## **BID ADDENDUM NO. 3**

Prattsburgh CSD

Project: Capital Improvements Project – Phase 2

HUNT No.: 2716.025

**AD3-A1**  
PROJECT NO: 2716.025

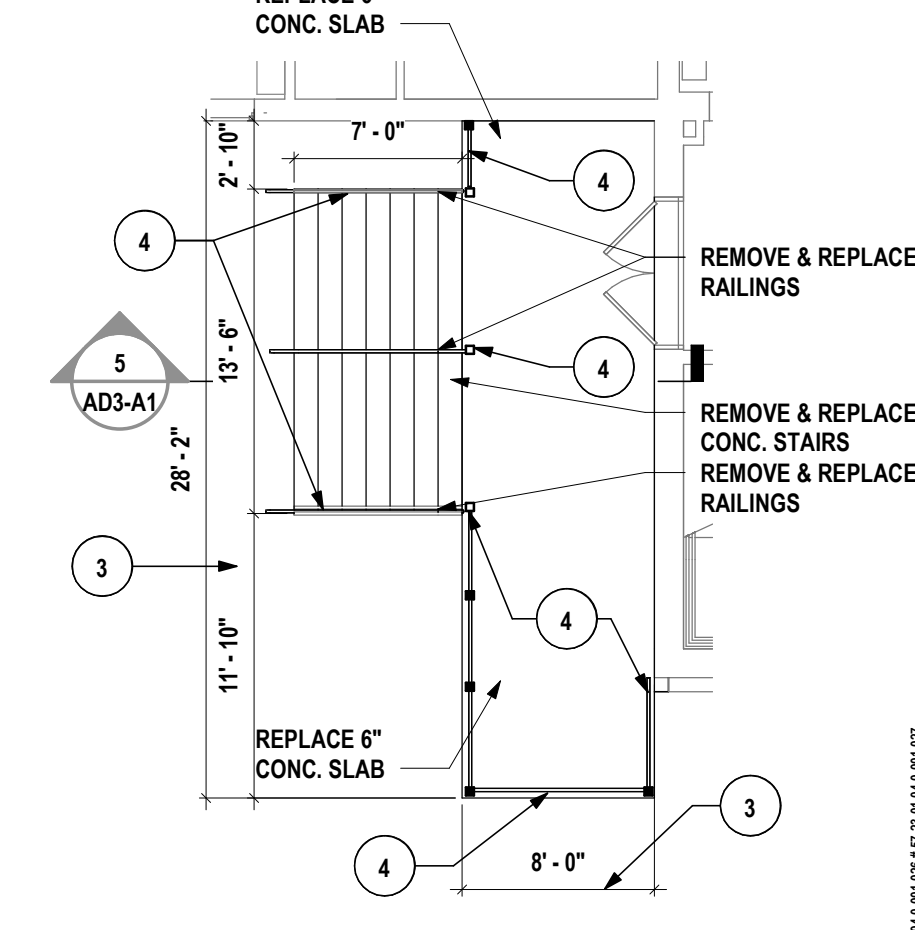
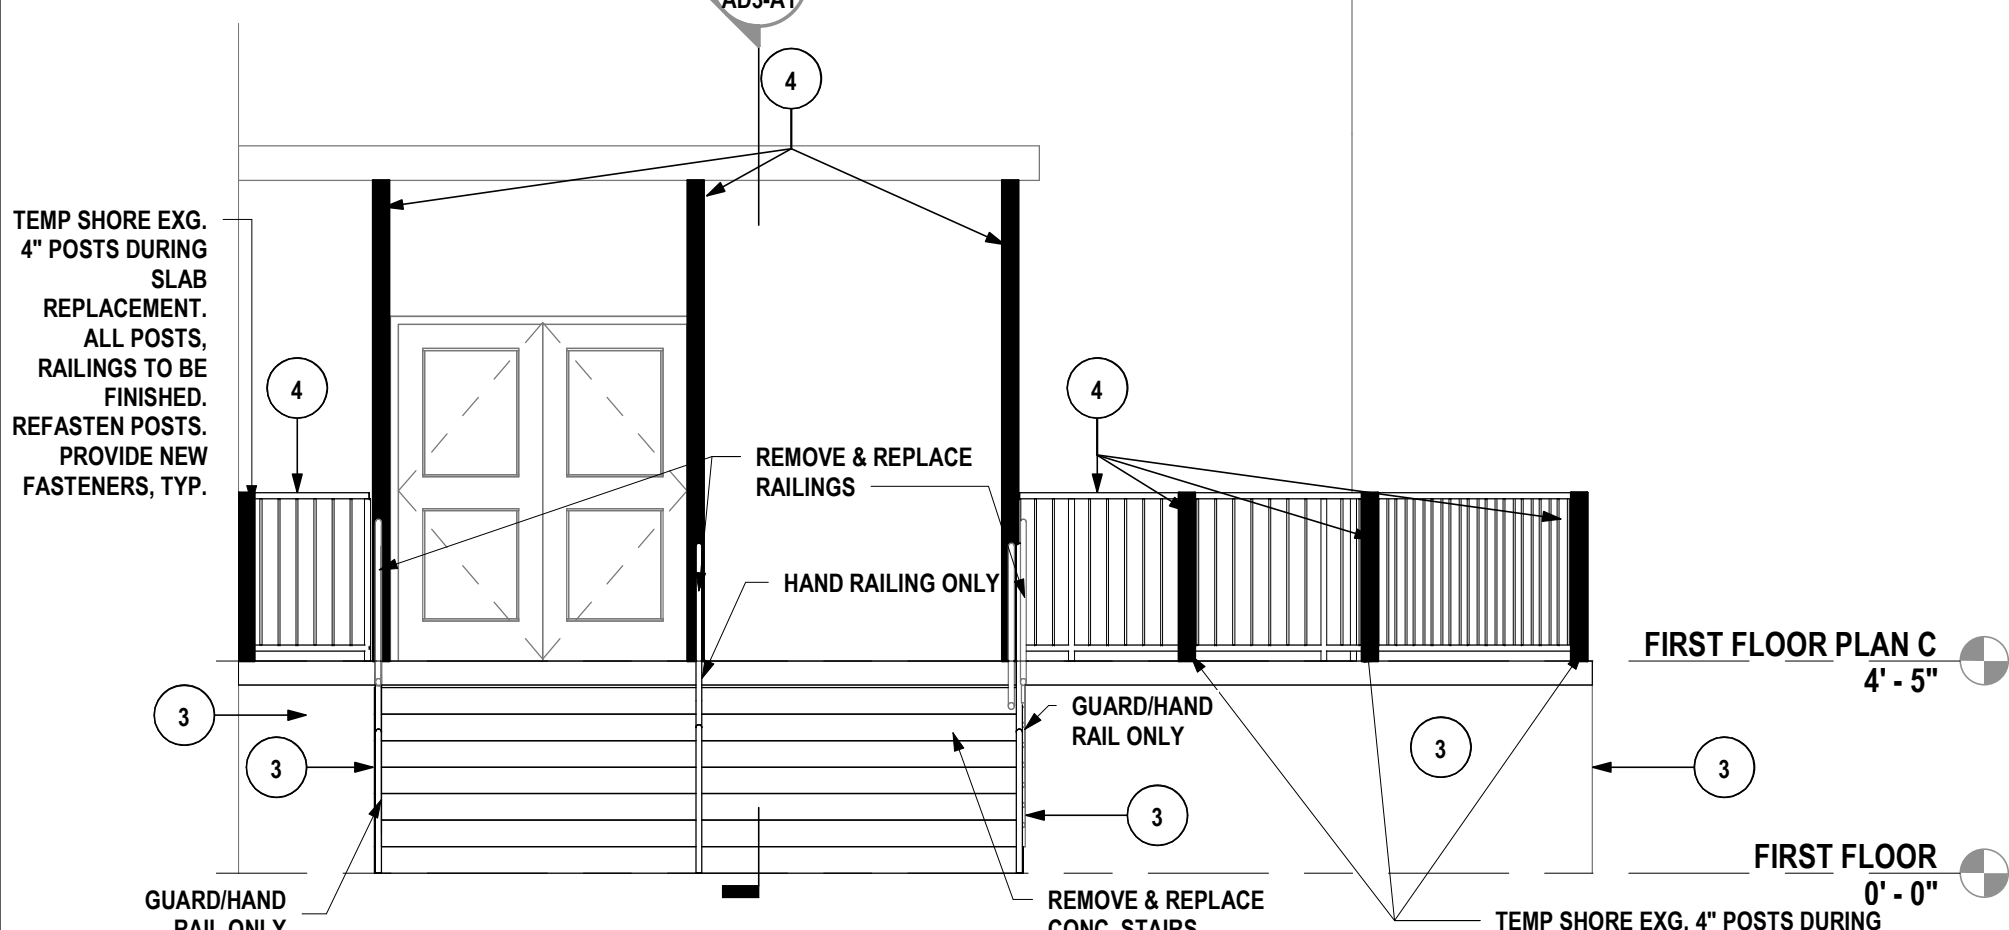
#### **ITEM AD3-1 Refer to Drawing A-1.3 – First Floor Plan – Area B**

AMEND drawing details 1 & 2 as per the attached drawing “AD3-A1- Stair Replacement @ Loading Dock”.

**AD3-A2**

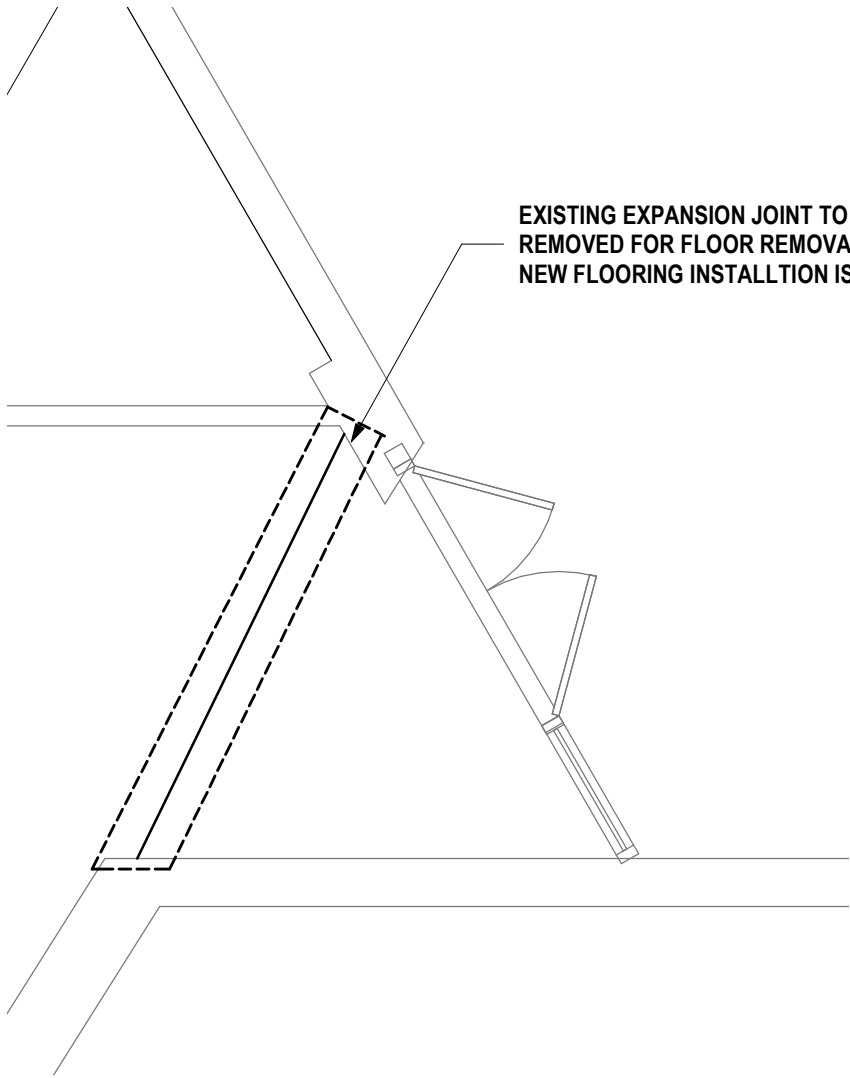
#### **ITEM AD3- 2 Refer to Drawing A-8.2 – First & Second Floor Finish Plans**

AMEND Detail 4 First Floor Finish Plans Area A & B scope to reflect changes shown on “AD2-A5- Area A Corridor Expansion Joint”.

EXISTING EXPANSION JOINT TO BE PARTIALLY  
REMOVED FOR FLOOR REMOVAL. RE-INSTALL ONCE  
NEW FLOORING INSTALLTION IS COMPLETE.
